STAFF REPORT
ST. VINCENT DE PAUL SOCIETY OF LANE COUNTY
19,715 SF RETAIL DEVELOPMENT WITH DRIVE-UP DONATION FACILITY
SITE DESIGN REVIEW SDR 3-22
DECEMBER 21, 2022

PROPOSAL DESCRIPTION

Location: 910 Row River Road
20-03-27-31 00210 & 00211

1 BUILDING ELEVATION - SOUTHWEST
1/8" = 1'-0"

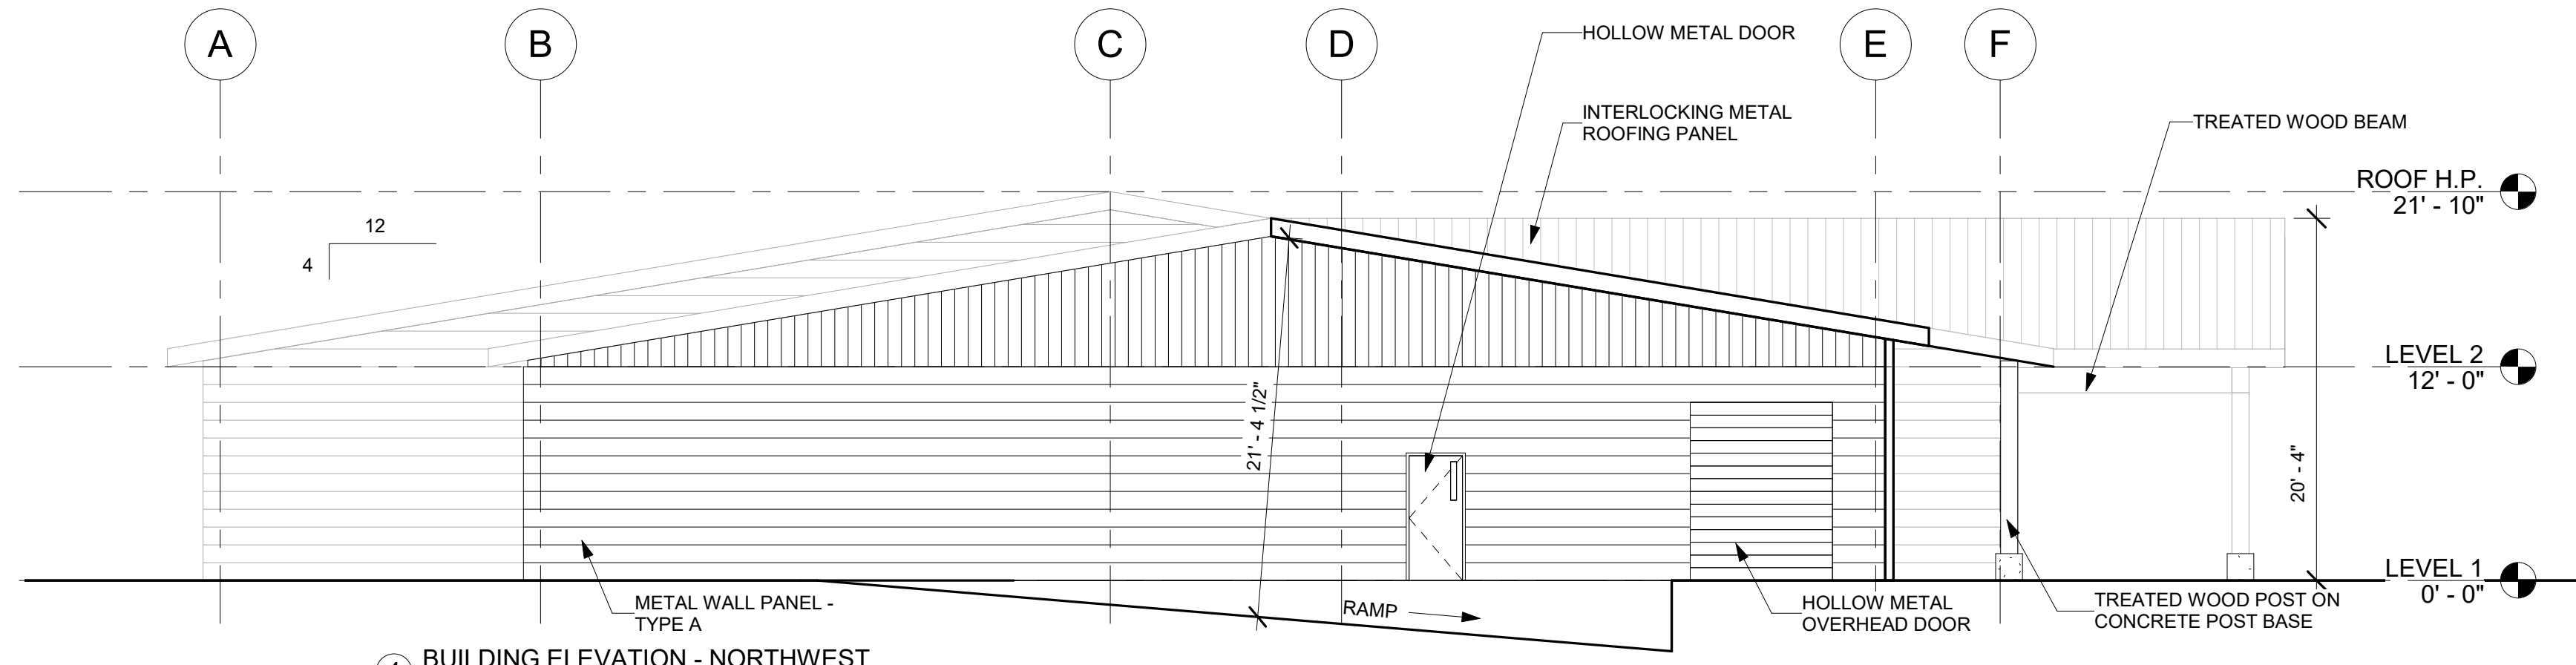
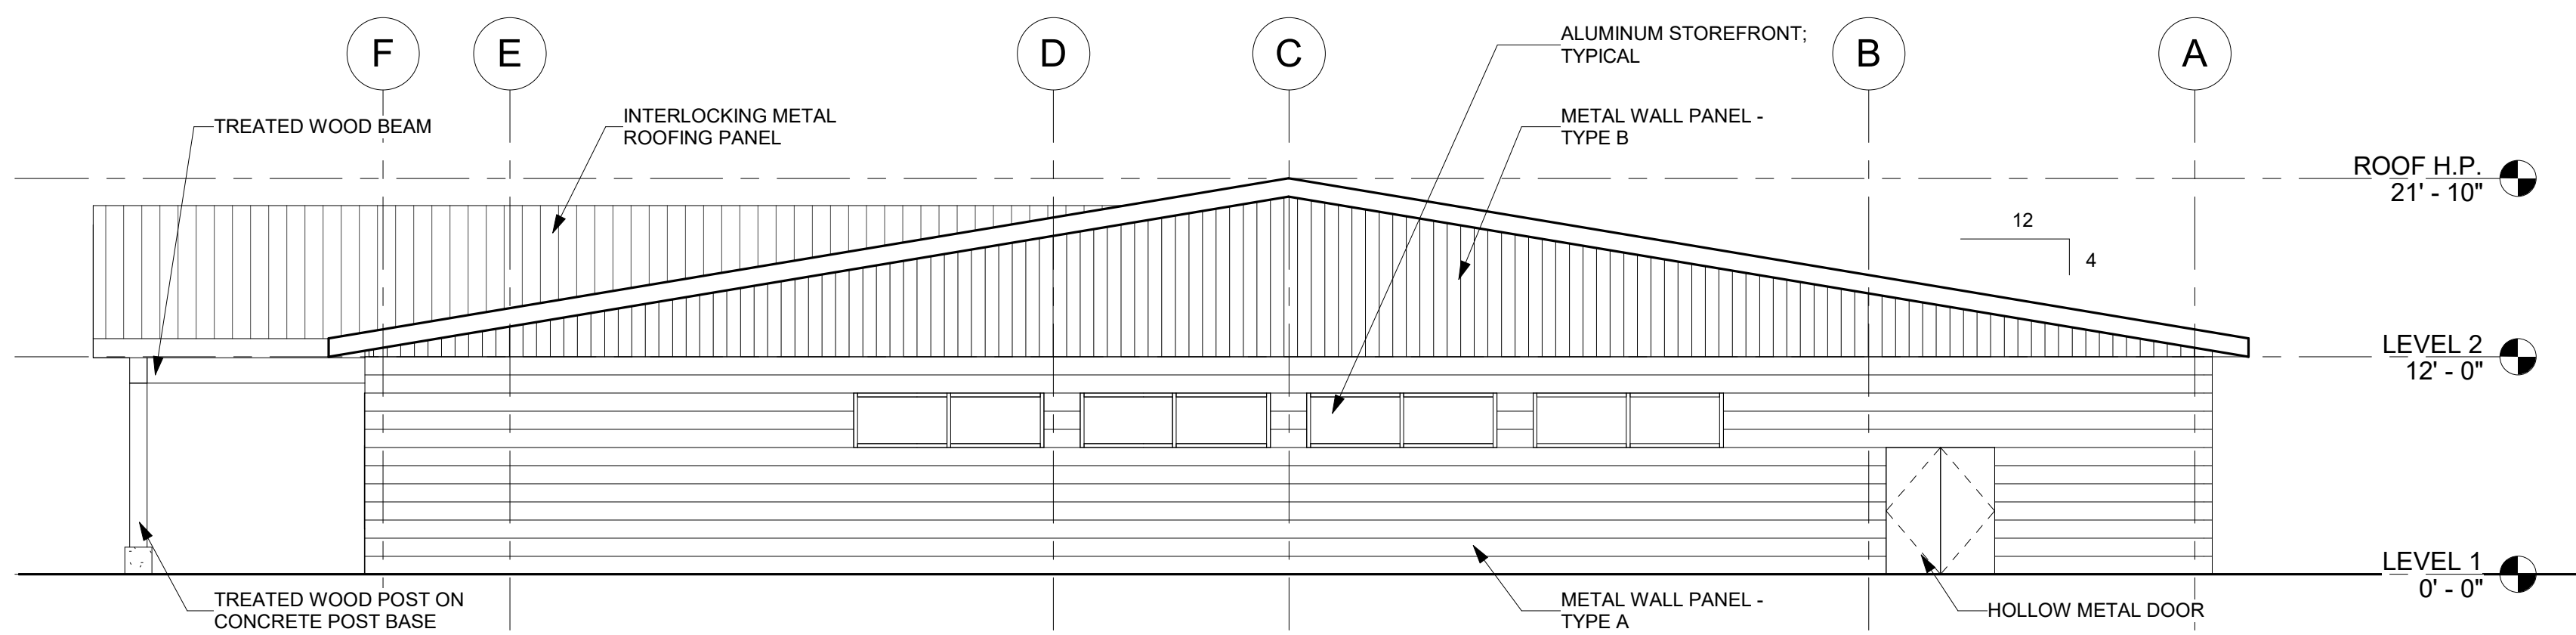
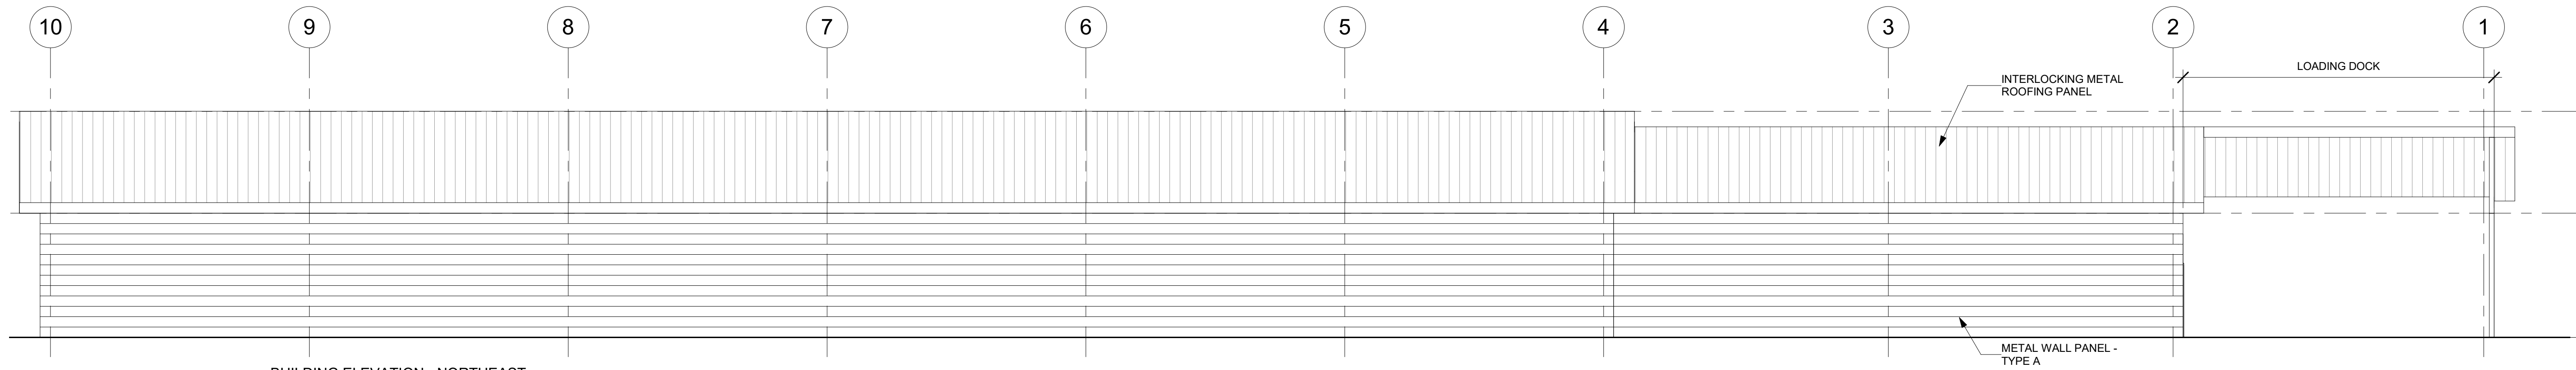
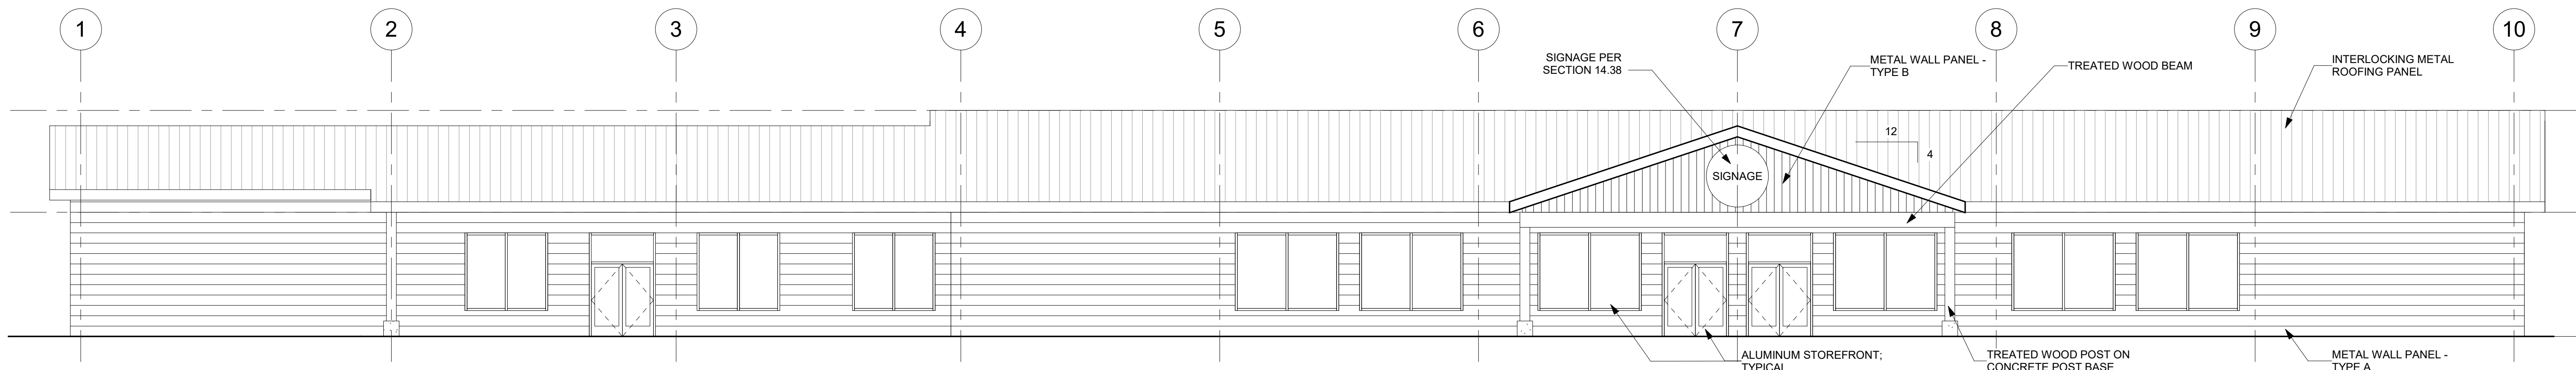
Staff response and findings of fact: The windows and windows/door openings are placed in a typical pattern and orientation to both create architectural style and to meet the glazing requirements of the code. The Row River Road façade includes eight and ten foot wide windows in a regular pattern centered on the gabled covered entry. This criterion is met.

Staff response and findings of fact: The proposed facade along Row River Road provides windows, primary entrances, weather protection, offsets, and/or projections every 30 horizontal feet maximum. The façade along Thornton Road provides windows every 30 horizontal feet maximum. This criterion is met.

ARTICULATED FACADE DIAGRAM - ROW RIVER ROAD
 1/16" = 1'-0"

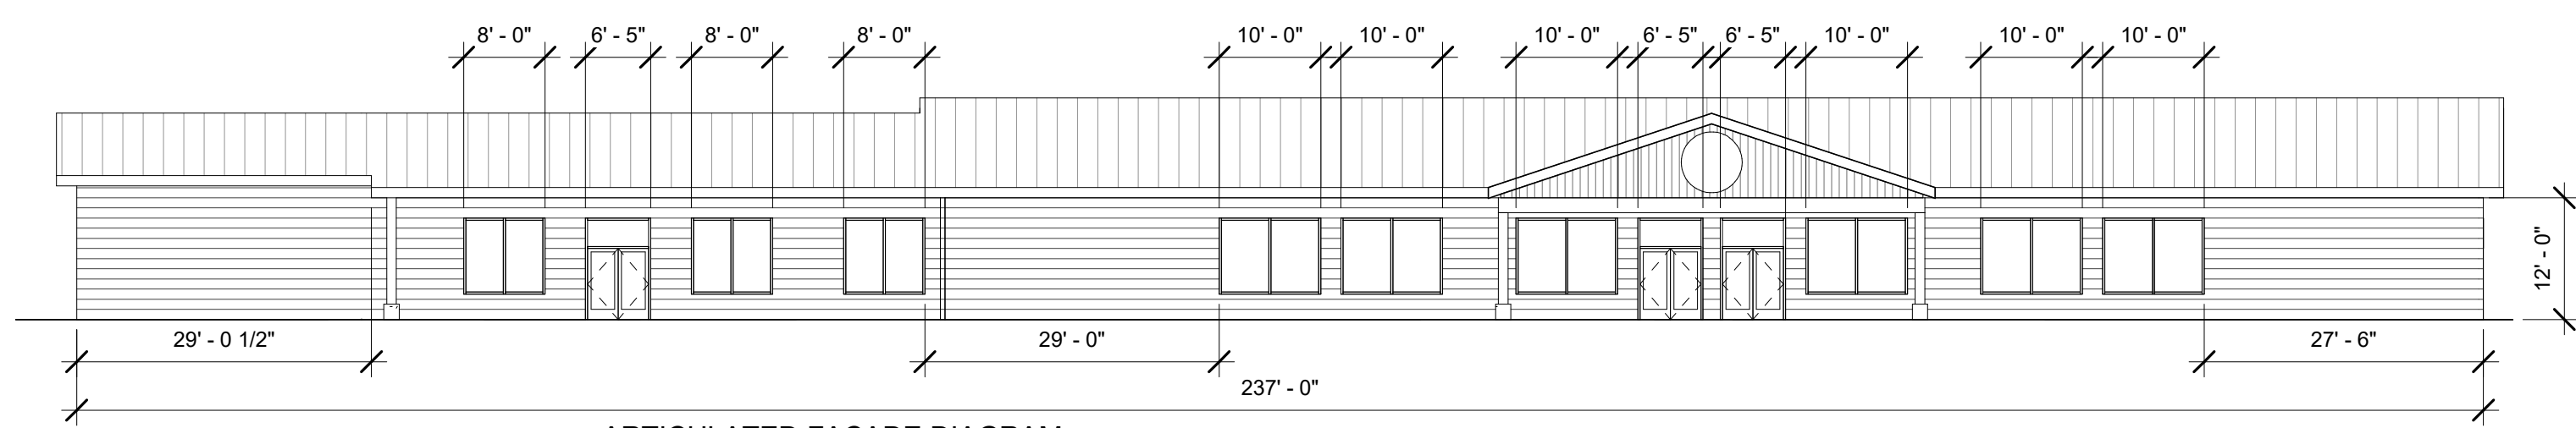
Staff response and findings of fact: The proposed building has two street-facing elevations, Row River Road (front) and Thornton Road (southeast). The total length of the front facade (Row River Road) is 235'. To meet the above standard, windows or window displays must be provided along a minimum of 40% of the street-facing elevation, or 94'. The proposed facade has approximately 110' feet of windows or window displays along the front facade. On the southeast (Thornton Road) façade the total façade length is 100' requiring 40' of windows or window displays. The applicant has shown 40' or 40% of the southeast façade with windows. This criteria is met.
